Amended  
Environmental  
Assessment - S75W  
Western Building

# SYDNEY SUPERYACHT MARINA MP09\_0165

Environmental Assessment

MP09\_0165 (MOD2)

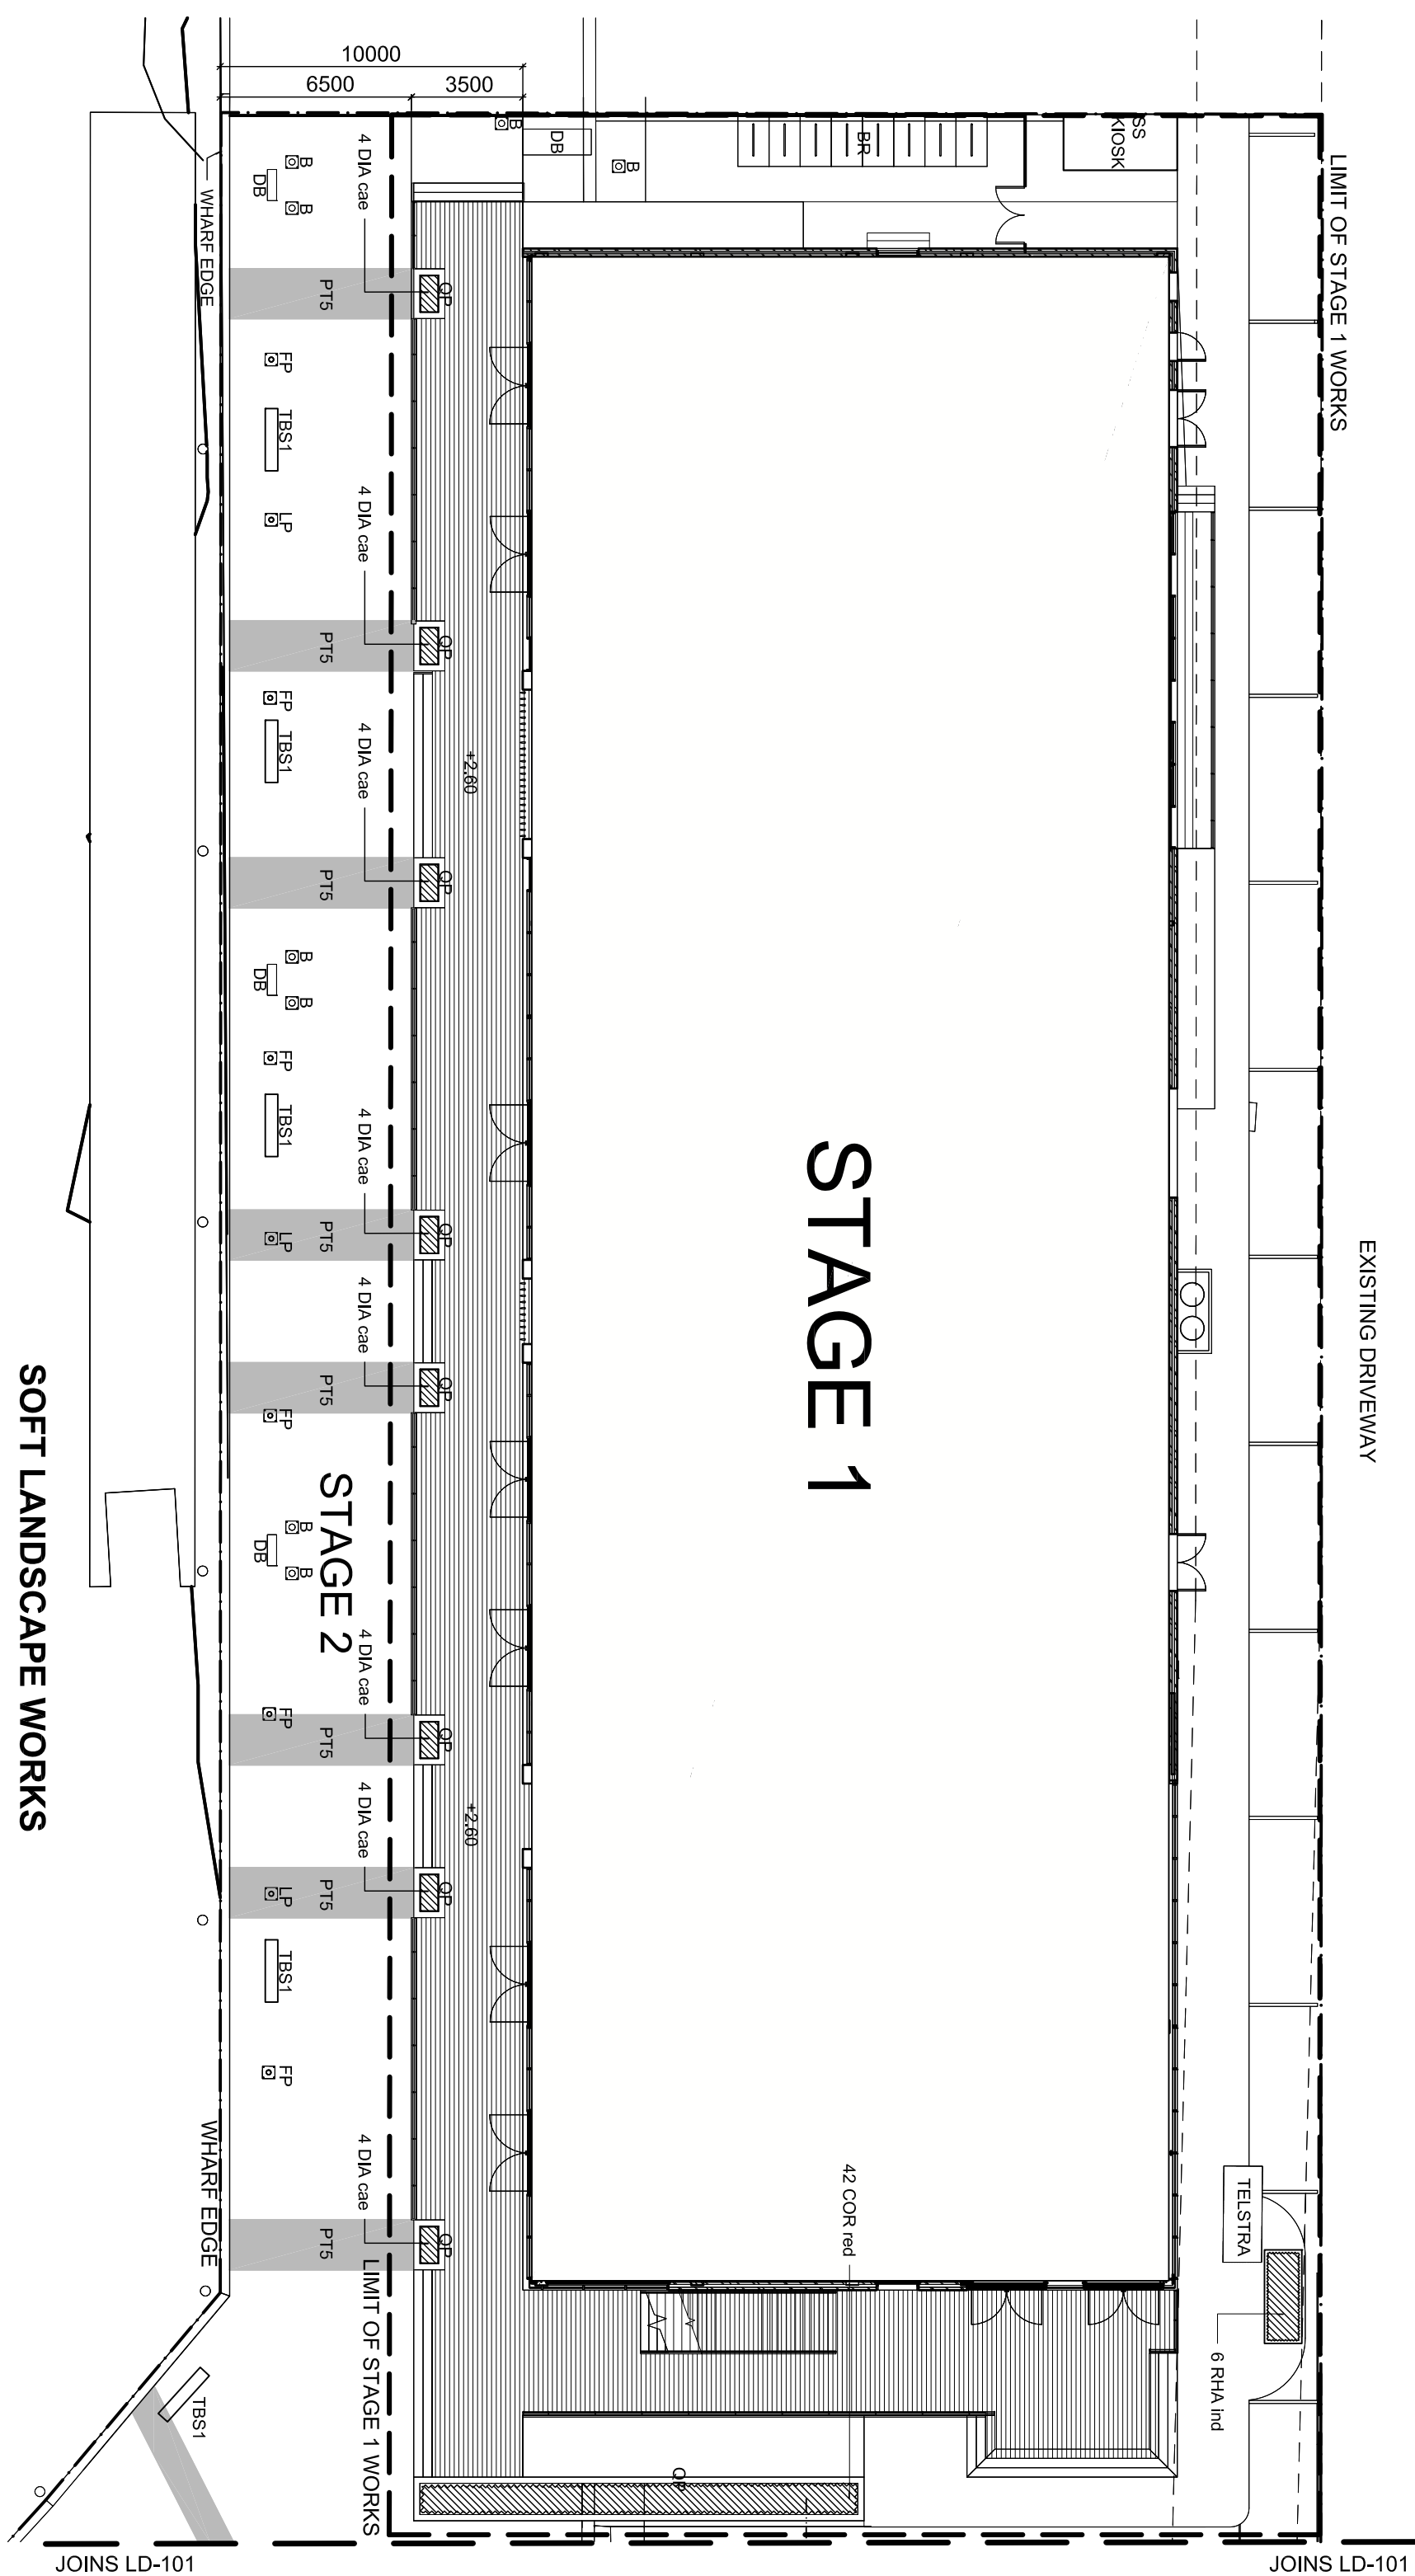
Further to the above, it is noted that you have also provided the department with Plan SK931-C dated 13/8/13 prepared by Scott Carver, which also illustrates the western building setout relative to the wharf edge. The department acknowledges that this plan illustrates consistent setbacks to the wharf edge with those details illustrated on Plan L 101 Rev.4, and that it is your intention to lodge a future s.75W application to rectify the alignment of the first floor level of the building with the detail shown on Plan SK931-C.

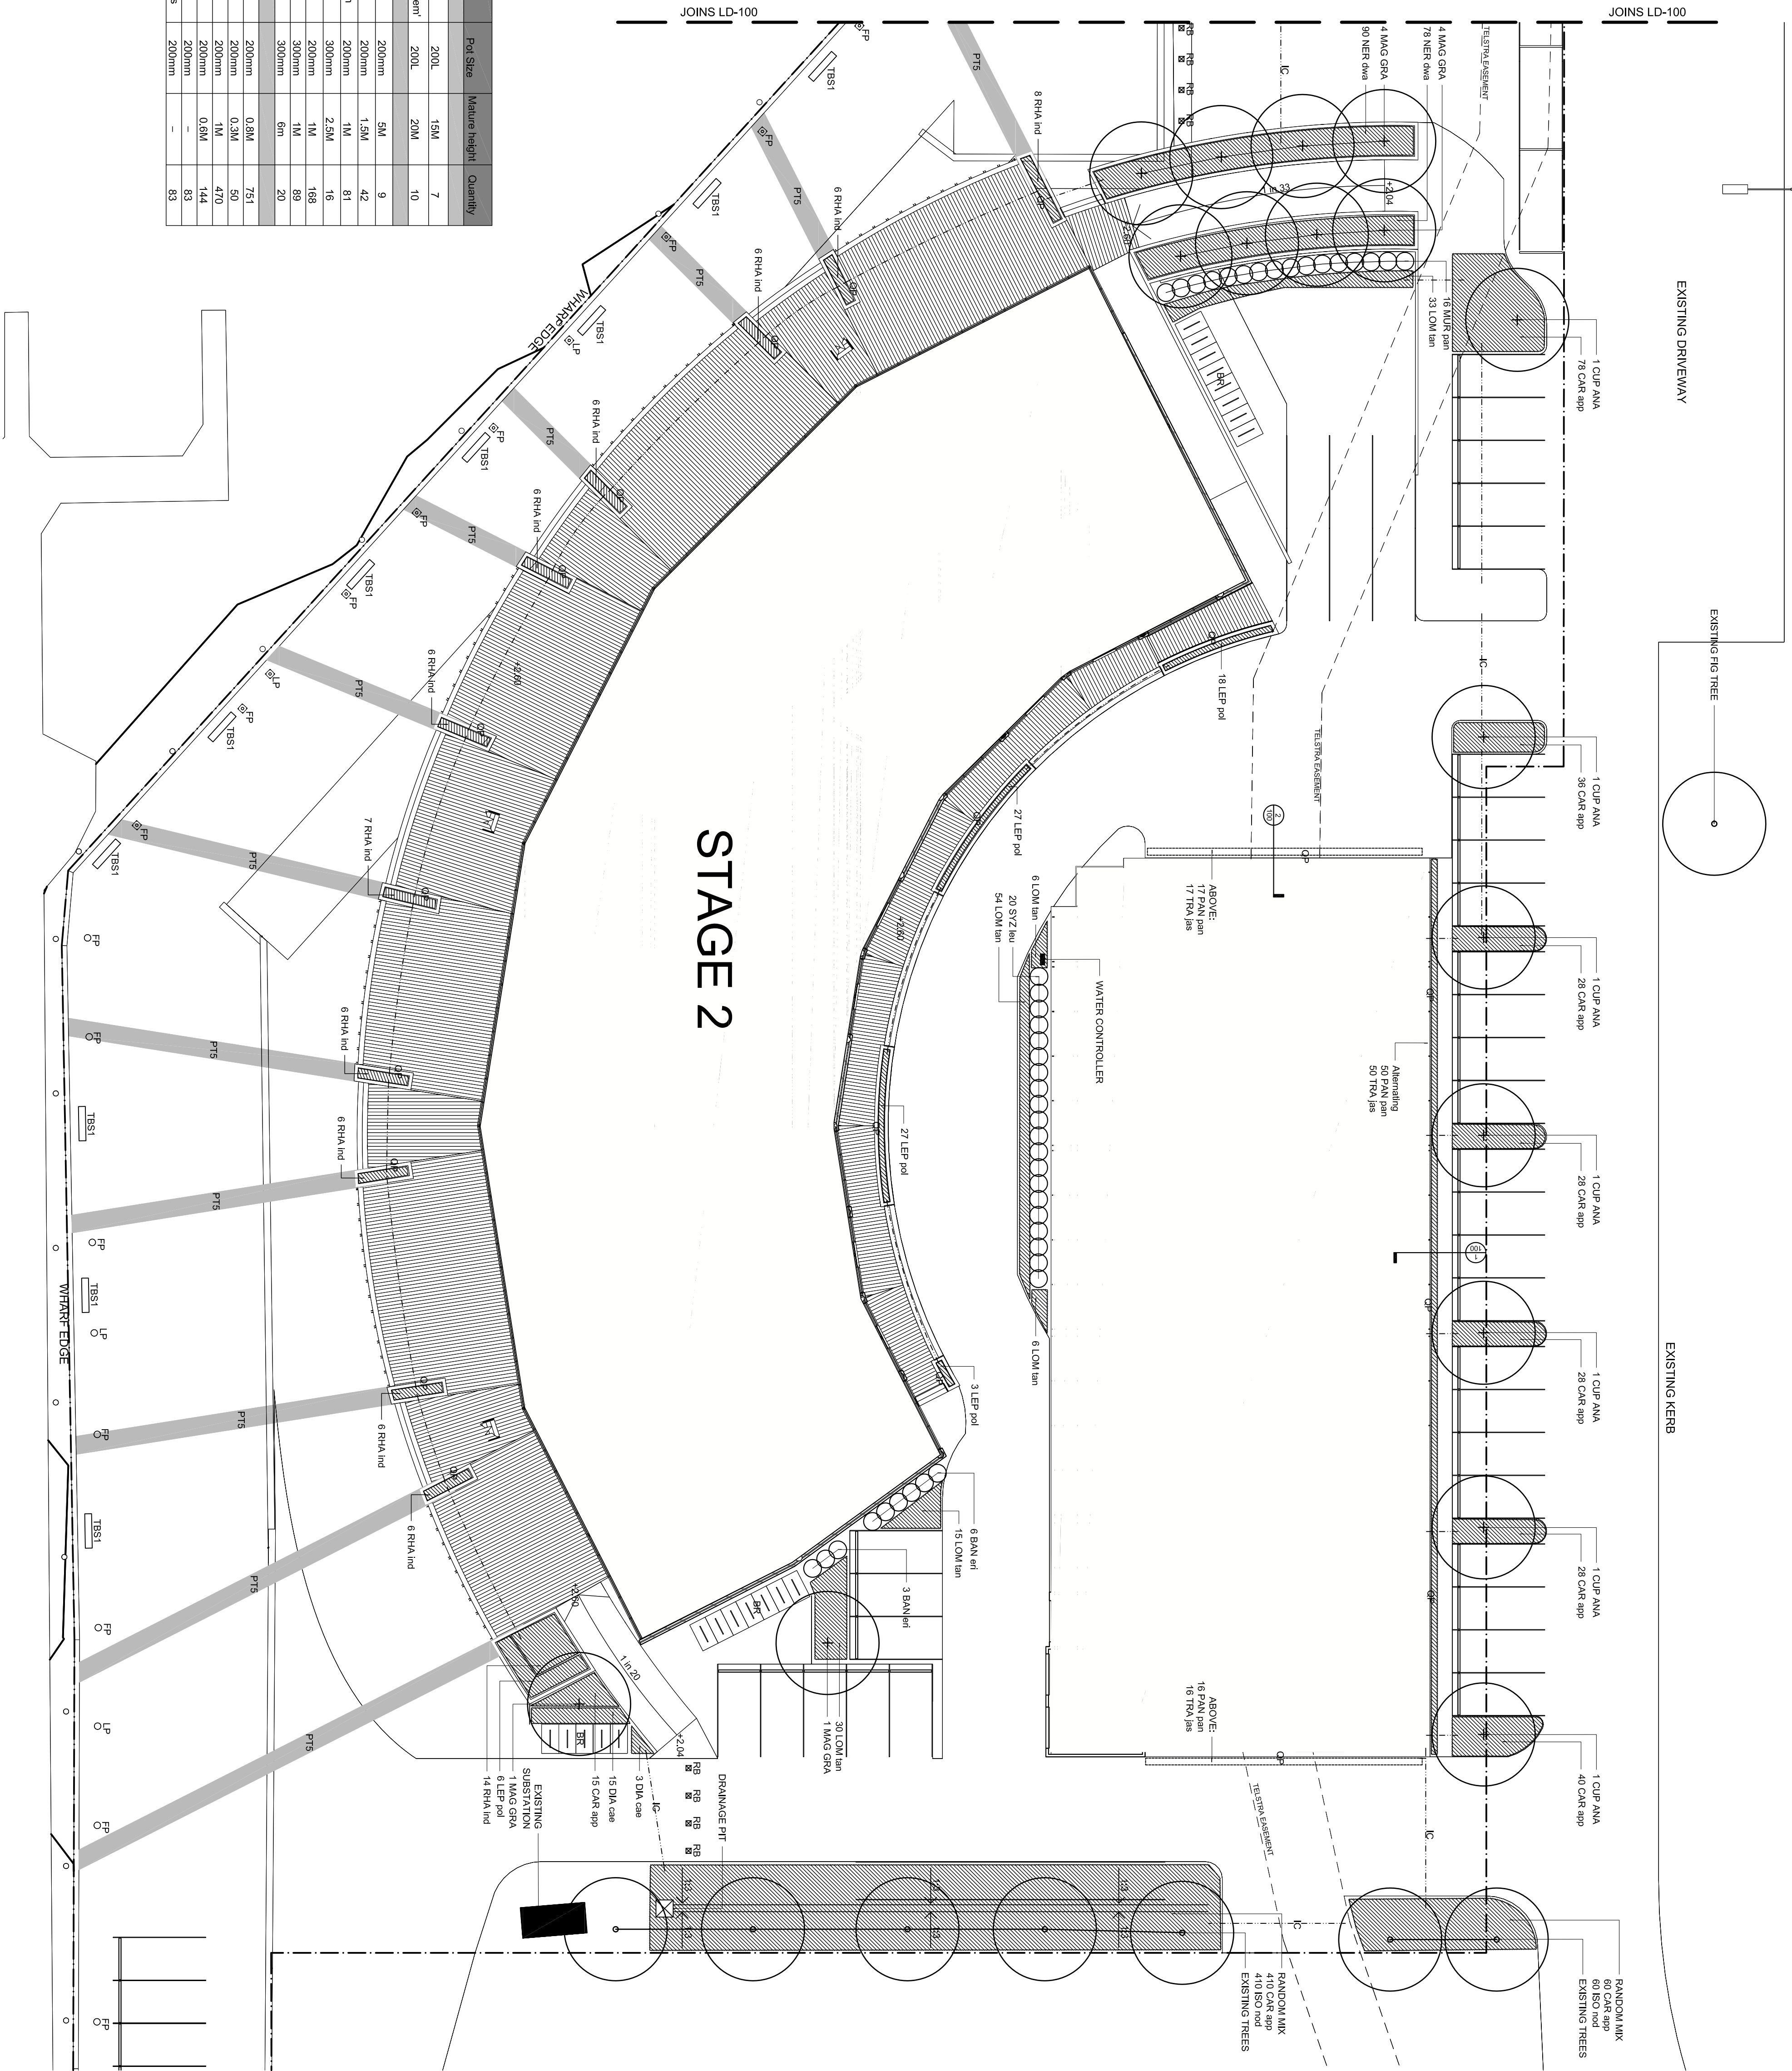
The department has reviewed your submission including the accompanying plans: L 100 Rev.05 Stage 1 Landscape Plan dated 12/8/2013 and L 101 Rev.4 Stage 2 Landscape Plan dated 9/8/2013 prepared by Scott Carver Pty Ltd. These plans detail the design resolution of the landscape treatment for the site, as required by Condition B2 of the approval. In this regard, Plan L 100 Rev 05 appropriately shows the setout details for the site, including to confirm that the façade of the western building at ground floor level will be setback 10 metres from the wharf edge, with the deck projecting 3.5 metres within this area. The department notes that the design of the deck and the planters are sufficiently resolved.

Having regard to the above, I can advise, as the nominee of the Director-General in accordance with the delegations dated 5 July 2012, that the above referenced plans are approved and the terms of Conditions B2 and B6 have been satisfied with respect to Stage 1 of the project.
